Appendix 6 – Technical Notes

DUBLIN AIRPORT
Technical Note 001
Airbridges

CIP2020+ Airbridges Rates Review

Re: Response to Dublin Airport CIP2020 Efficiency Assessment (Steer - May 2019)

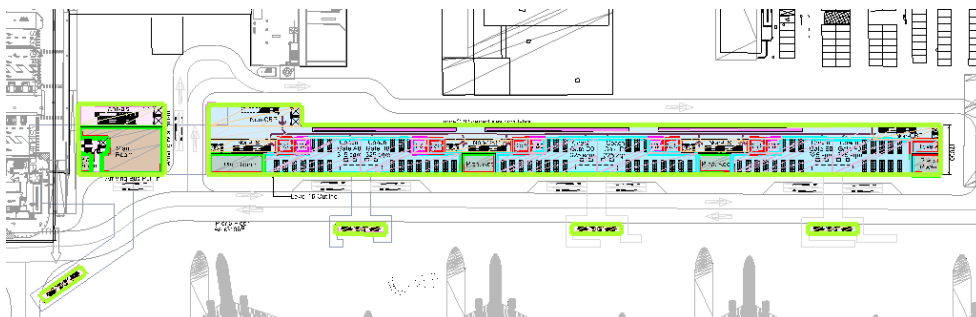
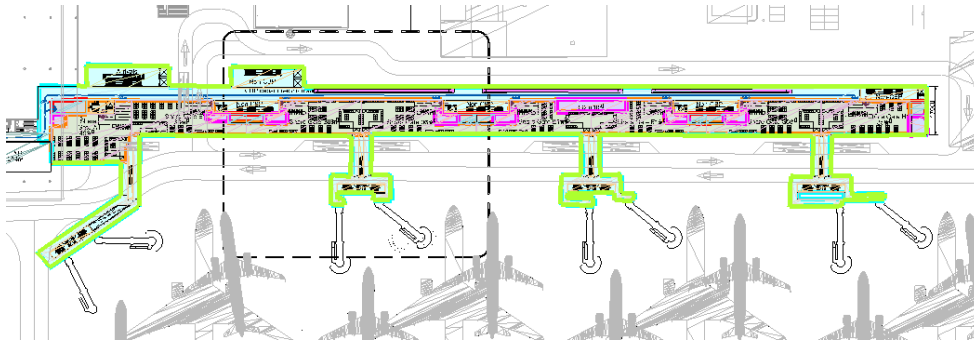
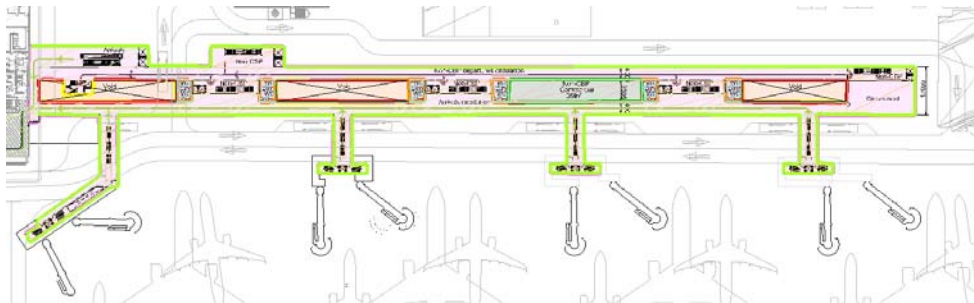
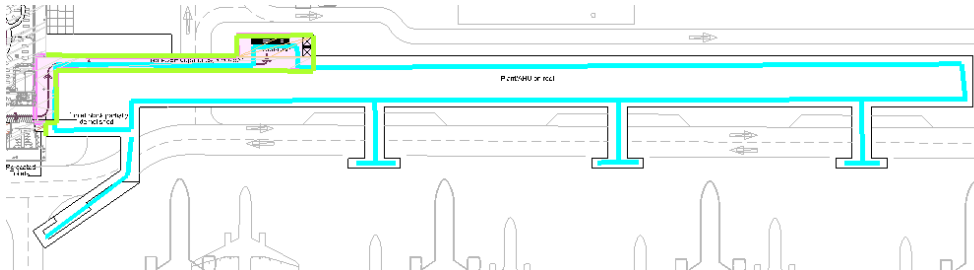
We note that Steer have revised their quantities from the draft determination, XXXXmsq to the current measure of XXXXXmsq which is closer to the Dublin Airport measure of XXXXmsq. There does however remain a difference between the take off areas:

- Steer have omitted the plant rooms. While the level of finish in a plant room is significantly less than elsewhere in the pier, and our rates are reflective of this; plantroom space still requires a level of fit out to make them suitable environments for operatives.

We have received no further detail from Steer in relation to the take-off of the external walls.

Further to provide further detail to TN005 the overall perimeter, for both glazed and clad walls is:

- Apron XXX m
- Level15 XXXX m
- Level 20 XXX m
- Level 30 XXX m
